ADDENDUM TWO
QUESTIONS and ANSWERS

RE: Addendum for Request for Proposal Number 4877Z1
to be opened April 23, 2015 at 2:00 p.m. Central Time

Attachment 1

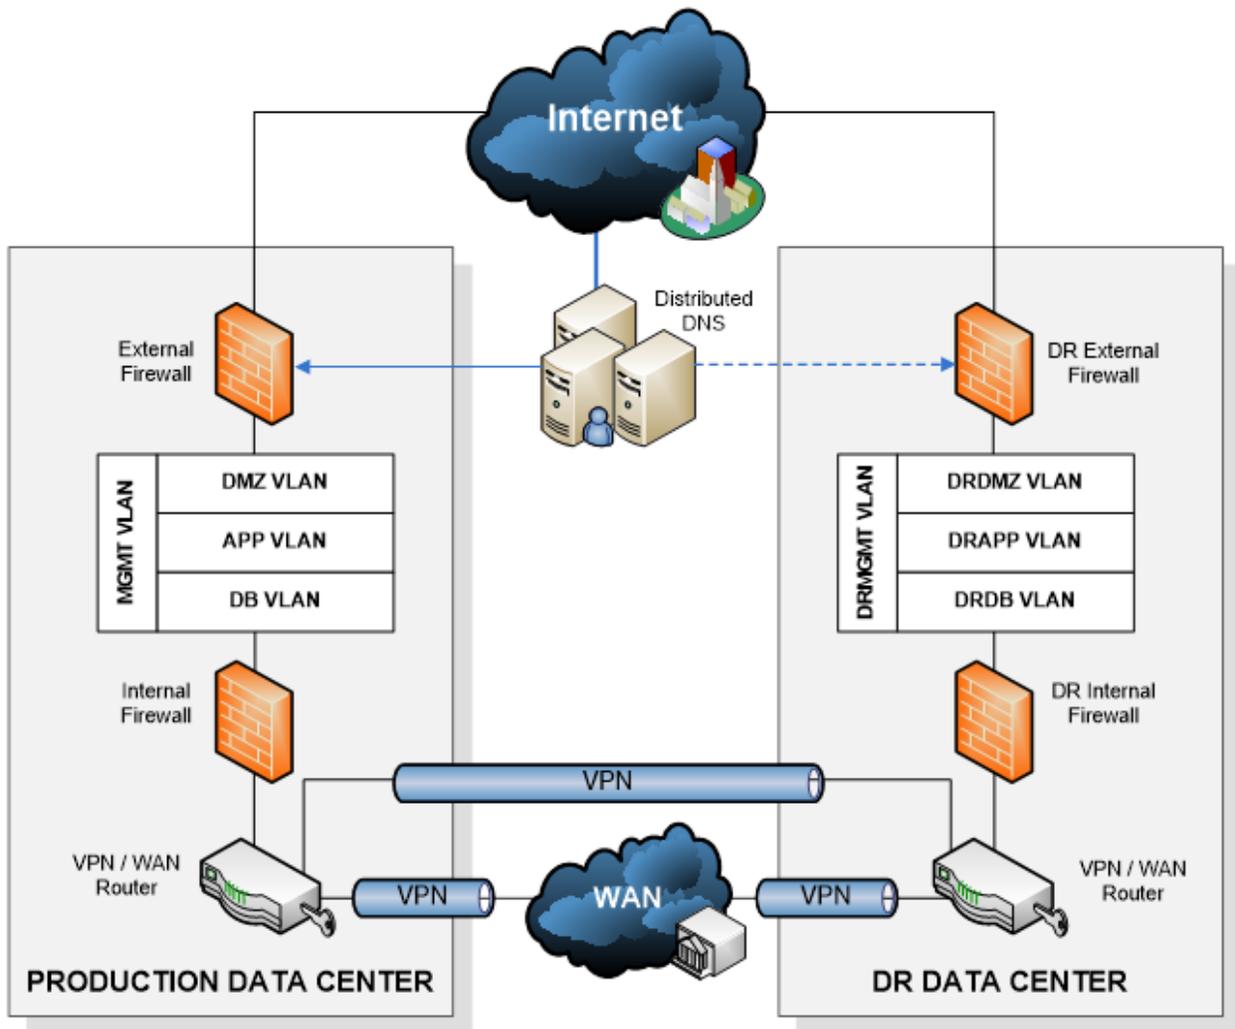
QUESTIONS	ANSWERS
1. Request current architecture diagram	See accompanying diagram and Attachment 1.
2. Need current performance and load test of the system - How many concurrent connection system is able to manage. Max load that is predicted	This information is not available for the system. The State cannot predict the max load for the resulting contract.
3. What hardware is required for managing the system	See the response to question #13.
4. Are there a requirement for mainframe?	No, there are no requirements for mainframe.
5. Does State provide the hardware for the system	No, the State does not provide the hardware to the Contractor for the system. The Contractor is responsible for their hardware costs.
6. Is there a requirement for 24X7 support?	Yes, and see Section IV. O. Technical Customer and User Support Requirement.

Architecture diagram from Question #1.
